RE: Application Reference: A007067229 - Development application for reconfiguring a lot (1 Lot into 2 Lots)

RE: DEVELOPMENT APPLICATION FOR RECONFIGURING A LOT (1 LOT INTO 2 LOTS)

Application Reference: A007067229
Subject Site: 17 Gunner Street, Kedron QLD 4031 (Lot 187 on RP45695)
Zoning Precinct: Character Residential (CR1 - Character Landscape) Zone Precinct

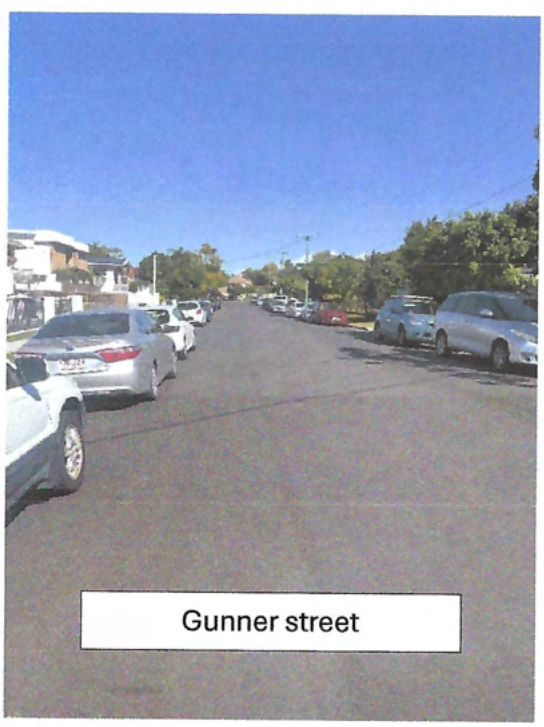
- **Statutory Clearance Impossibility:** Under Council's **Residential driveway permit requirements**, Standard Drawing BSD-2022, any new driveway crossover must maintain a strict minimum distance of 2.0 metres from the trunk of a cylindrical form (extending to 5.0 metres for buttress varieties).

- **Mathematical Infeasibility:** On constrained 9.153 metre frontages, it is mathematically impossible to construct side-by-side driveway crossovers while honouring these mandatory 2.0 metre to 5.0 metre buffer zones around the replaced trees. In response to community requests for the trees to be replanted, the Council has restored its infrastructure assets and remedied the stripping of the street's character canopy in time. The applicant has not provided a dimensioned crossover plan showing actual tree position, setbacks, driveway widths and available frontage. Doing so would prove that it is not possible to comply with all of the requirements for crossovers for two driveways.
